MIL-P–62211B(AR)
AMENDMENT 3
15 JUNE 1998
SUPERSEDING
AMENDMENT 2
07 JULY 1989

MILITARY SPECIFICATION

POWER SUPPLY, LOW VOLTAGE: 11746916

FIGURE 1. Power transients and +15V interlock.

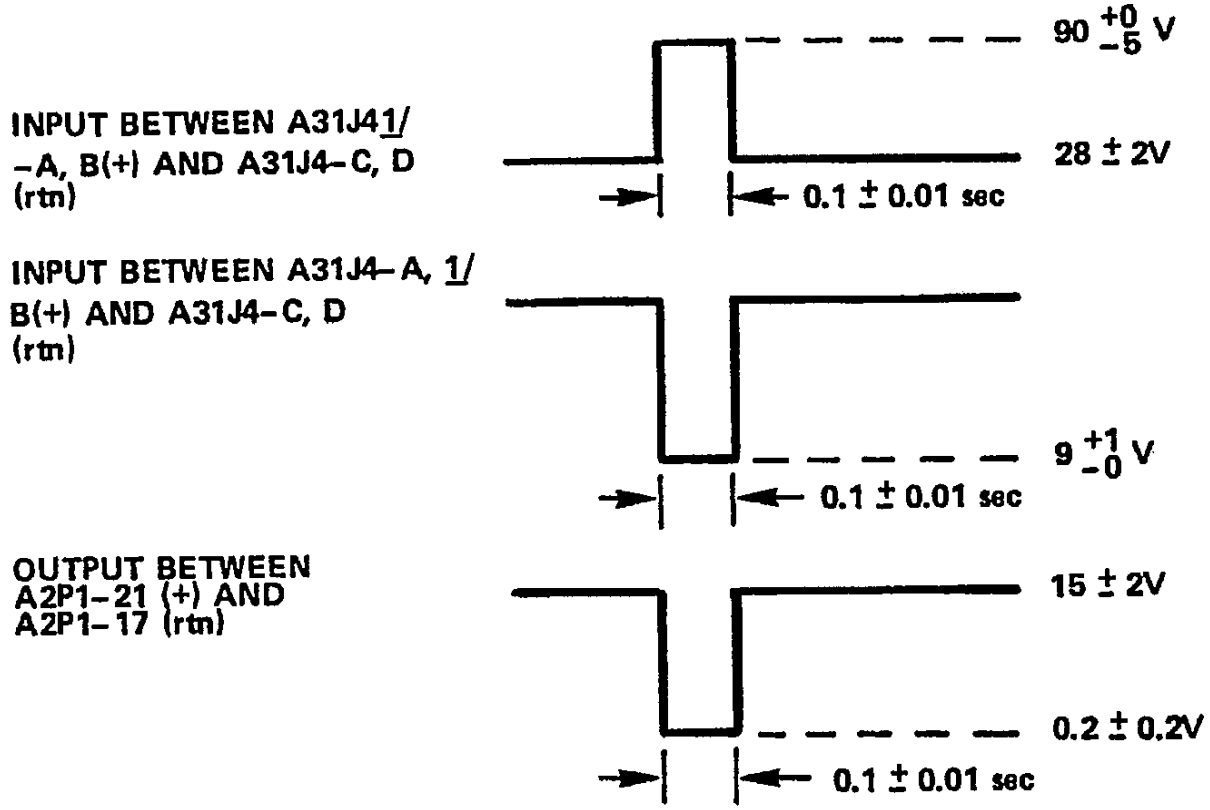
Figure 1: Delete in its entirety and substitute the following:

FIGURE 2. "Q" motor on-time limiting signal characteristics

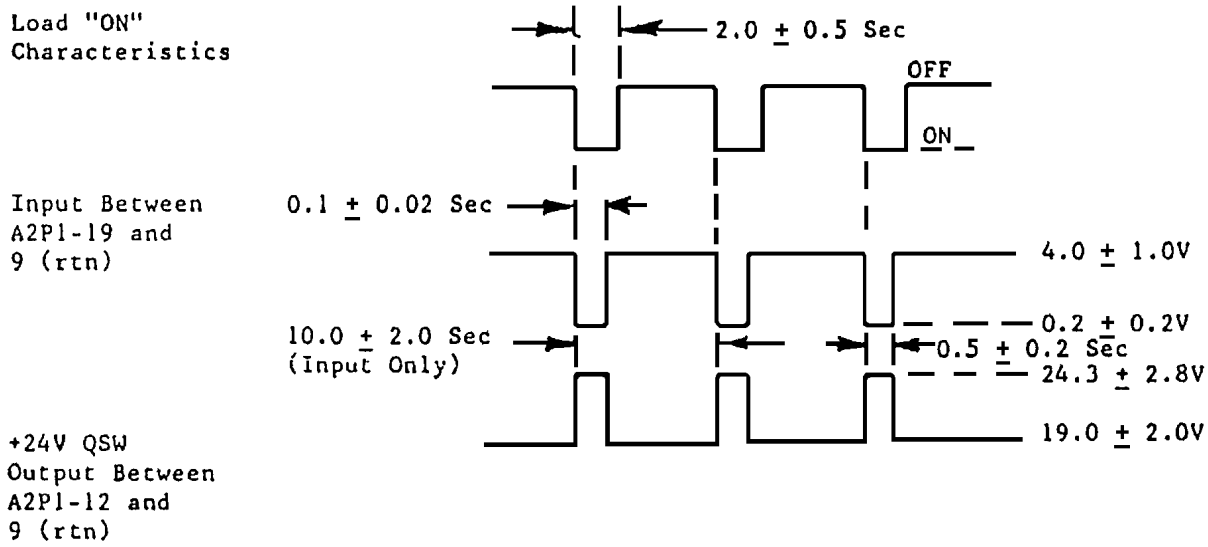
* Figure 2: Delete in its entirety and substitute the following:

FIGURE 3. Sync SIG A and Sync SIG B output characteristics

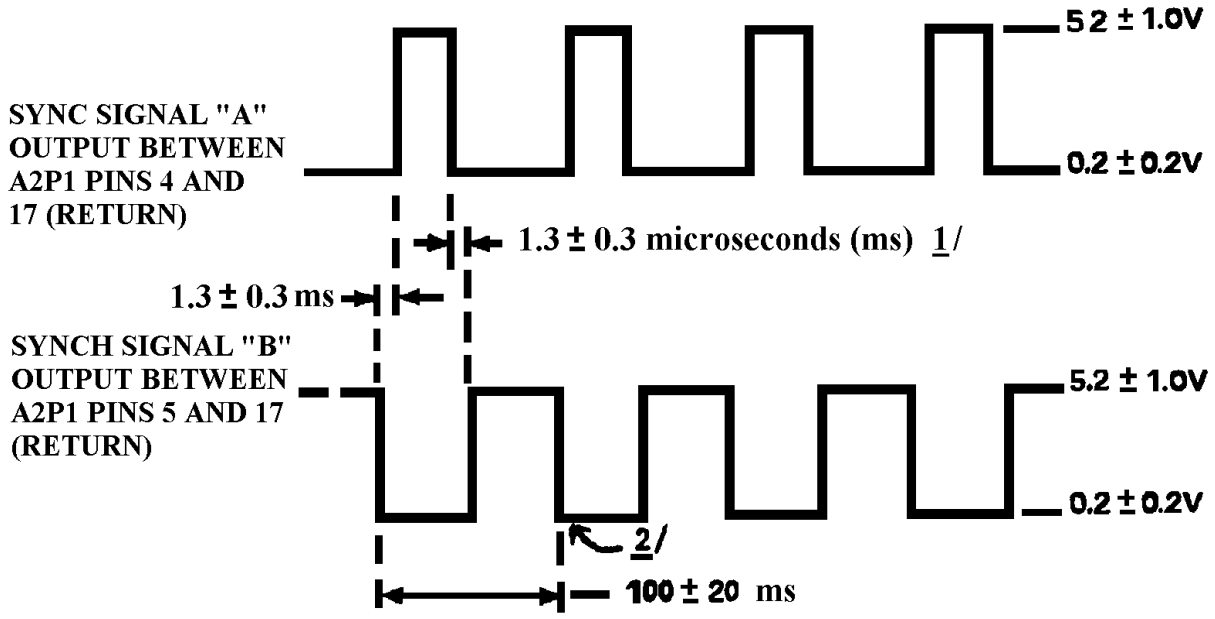
* Figure 3: Delete in its entirety and substitute the following:

1/ Time intervals are specified at the 50% point of the pulse amplitude.

2/ Overshoot on leading and tailing edge is allowable (Neg shoot approx -2V at 6.2 microsec)
